TOWN OF KITTERY

Planning Board Meeting March 14, 2024

ITEM 2—90 US Route 1—Major Site Plan — Preliminary Review

REDEVELOPMENT PLAN OF LAND OF 90 US ROUTE 1, LLC

SUBSURFACE SAND FILTER DETAIL
NOT TO SCALE

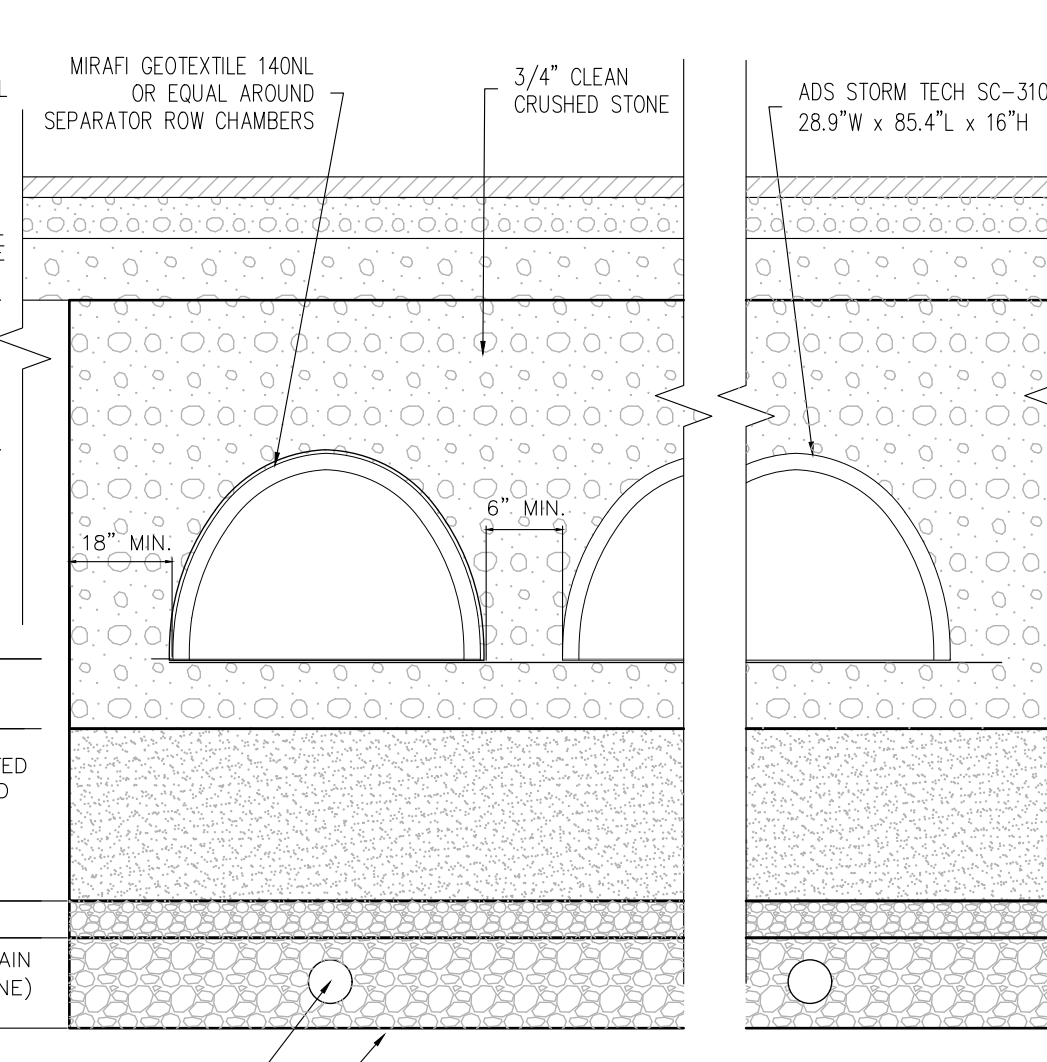
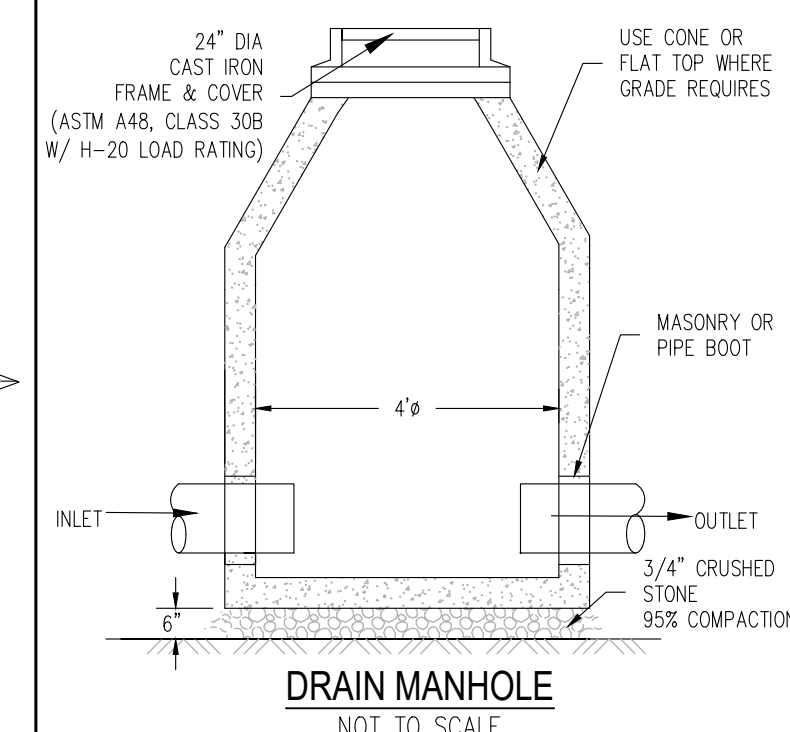
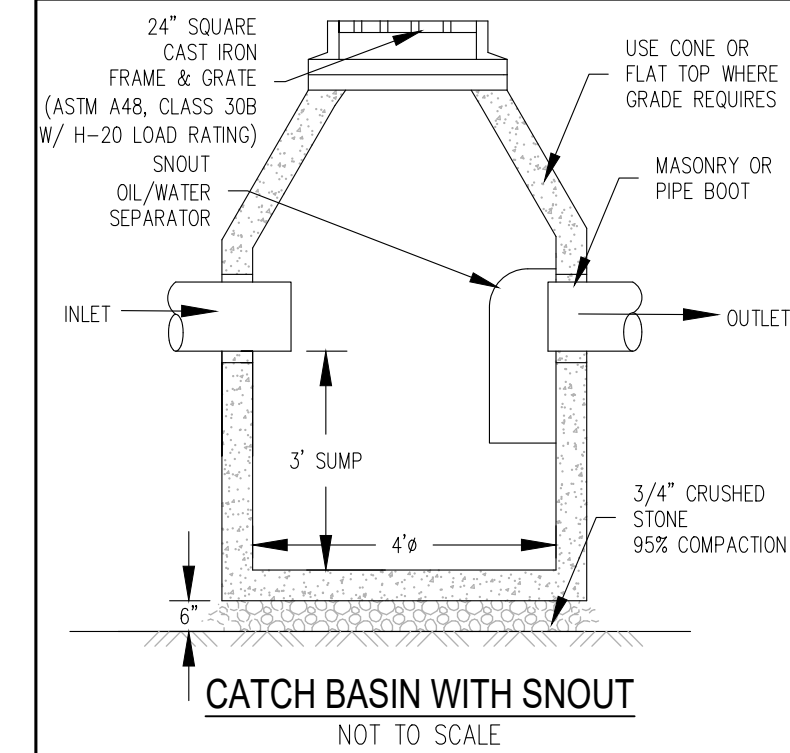
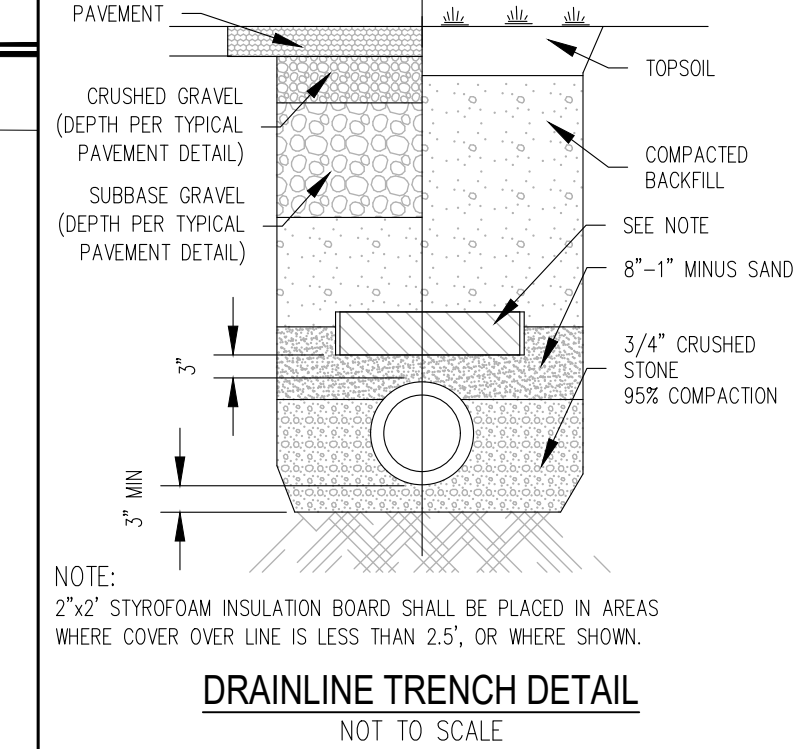
<p><u>Sheet L3 -Construction Details</u></p> <ol style="list-style-type: none"> 1. The type of frame and grate/cover with H-20 loading should be specified on the Catch Basin with Snout and Drain Manhole details. 2. The fill above the Subsurface Sand Filter should be specified on the detail. 3. The location of inspection ports should be shown on Sheet L1 and on the Subsurface Sand Filter Detail (Plan View). 4. Provide a detail for the detectable warning surface. 5. Why is there a cloud around the Typical Sidewalk Ramp detail? 6. The Service Connection Detail is not reflective of this project. Provide a detail that applies. 7. Where is the Gate Valve located? 8. There should be warning tape on the Sewer Line Trench Detail. 9. There should be warning tape on the Water Line Trench Detail. 10. Provide details and/or information on the proposed directional drilling under US Route 1 Bypass. 	<ol style="list-style-type: none"> 1. <i>Have been added to the details.</i> 2. <i>The base gravel fill has been specified on the plan. Added a new callout to the subsurface sand filter detail referencing the typical pavement section detail on plan sheet L2 for the various components of the 12" min fill & surface layer.</i> 3. <i>Inspection port locations have been added on sheet L1 and this sheets subsurface sand filter detail (Plan View).</i> 4. <i>A detail has been added to plan sheet L3 for the detectable warning surface.</i> 5. <i>The cloud indicates a revision from plans submitted to the Town. It has been removed from the plan.</i> 6. <i>The detail has been replaced with one from Kittery Water District that applies to this project and has been moved to the Utility Plan sheet. The intent is to work with the water district for all connections.</i> 7. <i>To be coordinated with Kittery Water District. Gate valve detail moved to utility plan sheet.</i> 8. <i>Warning tape has been added to the detail.</i> 9. <i>Warning tape has been added to the detail. Detail moved to the Utility Plan Sheet.</i> 10. <i>Details to be provided after coordinating with Kittery Water District.</i>

<p><i>Added a new callout to the subsurface sand filter detail referencing the typical pavement section detail on plan sheet L2 for the various components of the 12" min fill & surface layer.</i></p> <ol style="list-style-type: none"> 8. <i>The non applicable sections have been removed from the stormwater maintenance and inspection plan.</i> 9. <i>Spelling error corrected.</i> 10. <i>Riprap channels have been removed from the Vegetated Swales table.</i> 11. <i>Proposed access ports have been added to the subsurface sand filter detail on plan sheet L3.</i> 12. <i>See updated inverts for DMH 6 and CB 5 on plan sheet L1.</i>
<p><i>16.7.11.H. Exterior lighting requirements</i> There is glare beyond the property line on Old Post Road and at the site entrance on US Route 1 Bypass. The applicant should explore lighting that meets the ordinance or apply for a waiver.</p>	<p><i>Lighting plan has been updated.</i></p>

UTILITY PLAN

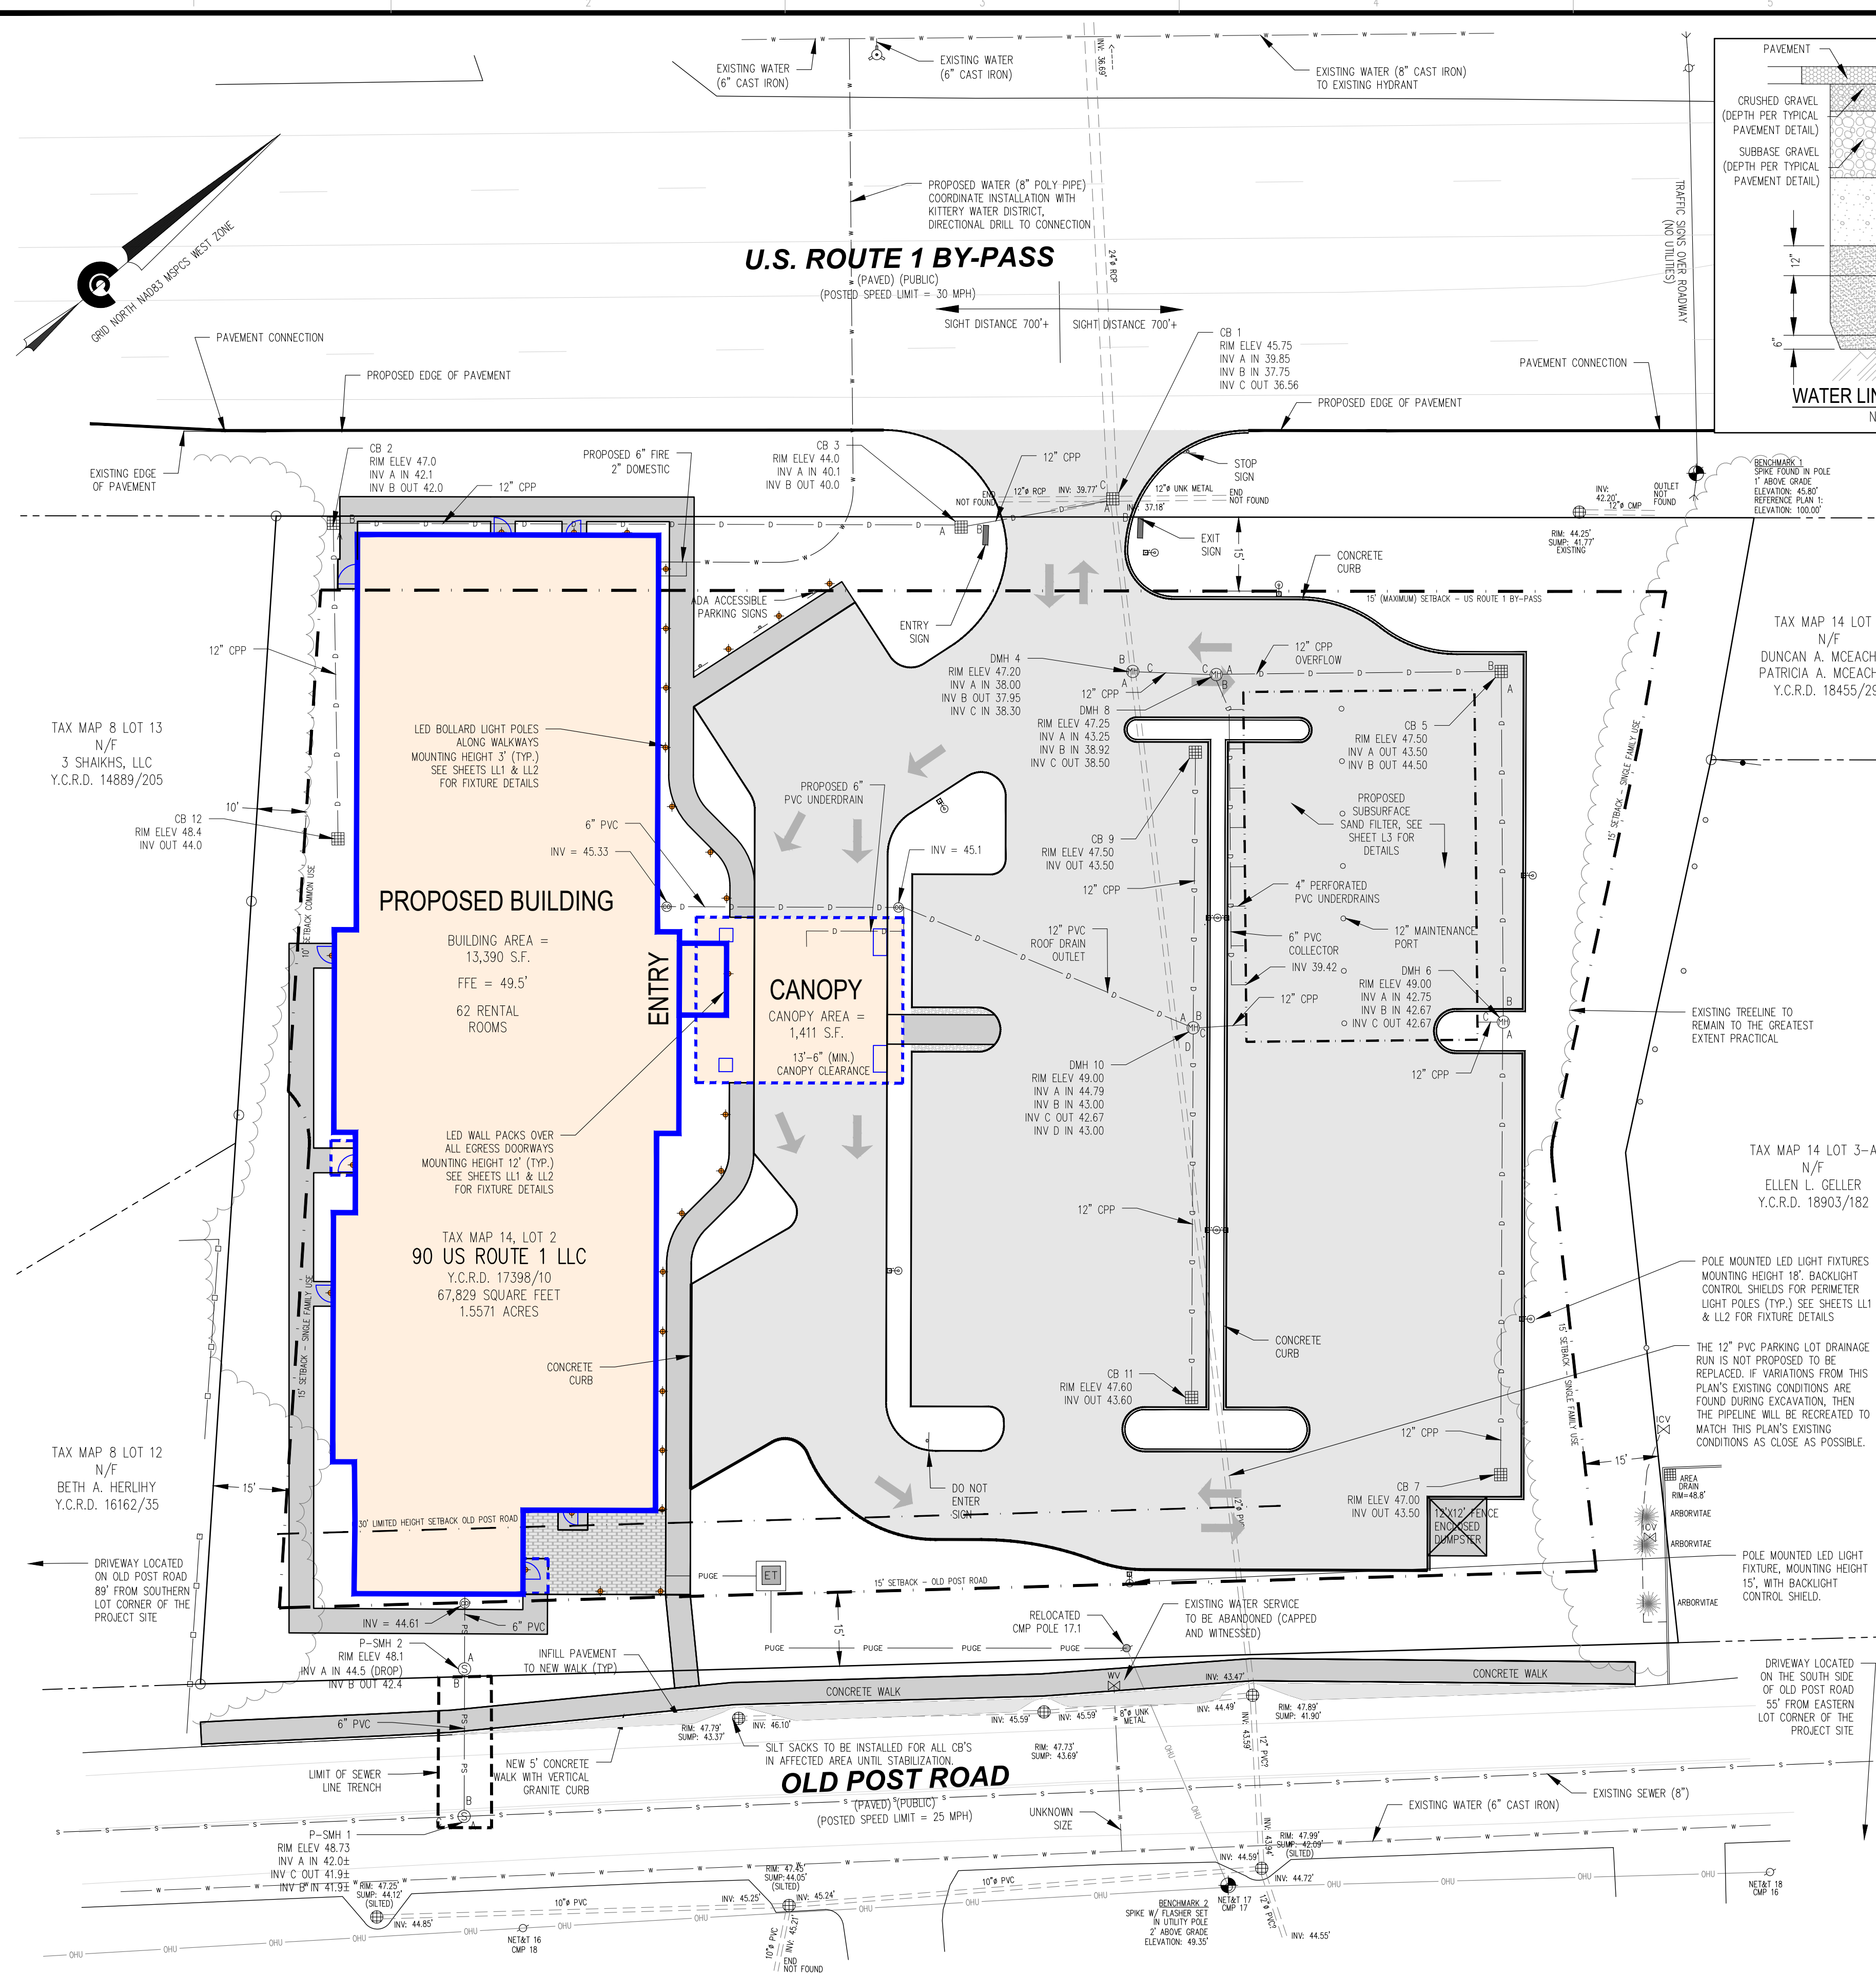
Sheet U1 – Utility Plan

1. Amend “Detail **Provided** by...” on Water Service Connection detail.
2. Provide information on directional drilling of water main.
3. Show the location of the gate valve.
4. Reference Sheet L2 for sewer, electric and drainage details.
